Project	IEEE 802.16 Broadband Wireless Access Working Group < http://ieee802.org/16 >	
Title	Reply Comment on Comment #3366	
Date Submitted	2005-03-14	
Source(s)	Kwangjae Lim, Chulsik Yoon ETRI 161 Gajeong-Dong, Yusong-Gu, Daejeon, KOREA	Voice: +82 (42) 860-6826 [mailto: csyoon@etri.re.kr]
Re:	IEEE 802.16e	
Abstract	Reply comment on Comment #3366	
Purpose	Reply comment on Comment #3366	
Notice	This document has been prepared to assist IEEE 802.16. It is offered as a basis for discussion and is not binding on the contributing individual(s) or organization(s). The material in this document is subject to change in form and content after further study. The contributor(s) reserve(s) the right to add, amend or withdraw material contained herein.	
Release	The contributor grants a free, irrevocable license to the IEEE to incorporate material contained in this contribution, and any modifications thereof, in the creation of an IEEE Standards publication; to copyright in the IEEE's name any IEEE Standards publication even though it may include portions of this contribution; and at the IEEE's sole discretion to permit others to reproduce in whole or in part the resulting IEEE Standards publica

Figure 229d—Mapping of the payload bit sequence to a Fast-feedback channel

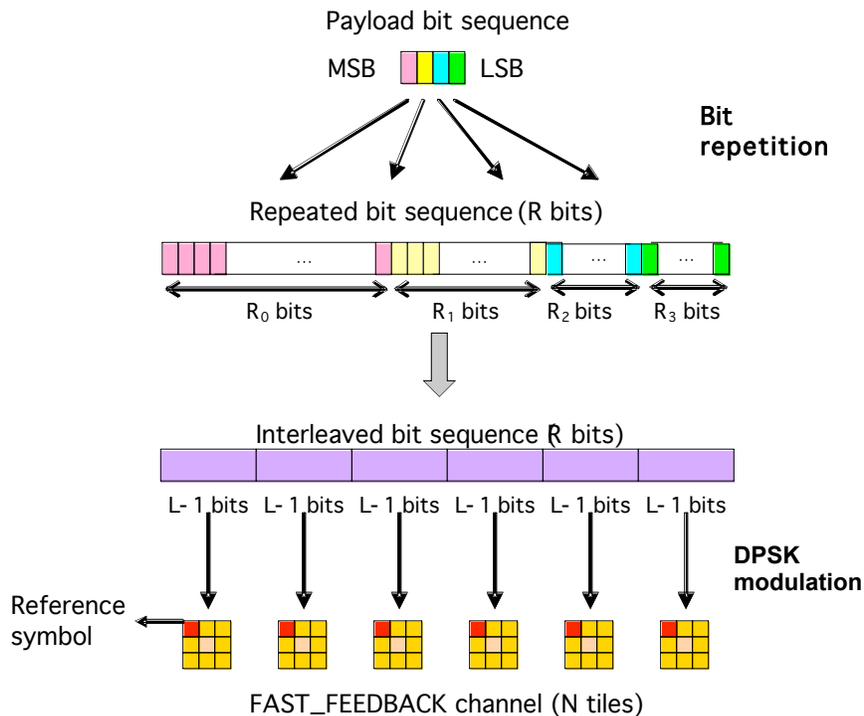
When the UEP fast-feedback is employed and the Fast-feedback allocation subheader Feedback type field is '00' or the BS requests the feedback through CQICH Alloc IE() or CQICH Control IE(), the MS may report the feedback payload on the assigned CQICH by using the following UEP fast-feedback method. The UEP ~~optional fast-DL-measurement feedback~~ feedback provides the payload bits carried by the Fast-feedback channel with the unequal error protection (UEP) capability. The UEP fast-feedback ~~optional fast-DL-measurement feedback~~ repeats each payload bit according to a predefined repetition ratio, as illustrated in Figure 229d. The repeated bit sequence is interleaved and used for binary DPSK modulation on the sub-carriers for the Fast-feedback channel.

When the MS reports the measured S/N, ~~Each~~ each payload bit is repeated according to the predefined UEP ratio $R_0:R_1:R_2:R_3$, where R_0, R_1, R_2 , and R_3 represent the repetition number for the 1st payload bit b_0 (MSB), the 2nd payload bit b_1 , the 3rd payload bit b_2 , and the 4th payload bit b_3 (LSB), respectively. In case of the 4-bit CQI payload, a ratio of $R_0:R_1:R_2:R_3 = 26:19:14:7$ is used for the 4 by 3 uplink tile structure, and $R_0:R_1:R_2:R_3 = 19:14:10:5$ is used for the 3 by 3 uplink tile structure. ~~In case of the 5-bit CQI payload, $R_0:R_1:R_2:R_3:R_4 = 24:18:12:6:6$ and $R_0:R_1:R_2:R_3:R_4 = 17:13:8:5:5$ are used for the 4 by 3 uplink tile structure and the 3 by 3 uplink tile structure, respectively.~~

where y denotes the bit index in the interleaved bit sequence ($y=0, 1, 2, \dots, R-1$), and x denotes bit index in the repeated bit sequence ($x=0, 1, 2, \dots, R-1$). The length of the repeated bit sequence is $R = R_0+R_1+R_2+R_3 = N(L-1)$ for the 4-bit CQI ~~or $R = R_0+R_1+R_2+R_3+R_4 = N(L-1)$ for the 5-bit CQI.~~

The interleaved bit sequence is divided into N groups and each group has $L-1$ bits. The n -th group ($n=0, 1, \dots, N-1$) is used for binary DPSK modulation on the subcarriers in the n -th uplink tile, as shown in Figure xxx. The first subcarrier in each tile is used as a phase reference. The $L-1$ bits in the n -th group are mapped to L DPSK symbols for the n -th tile as follows.
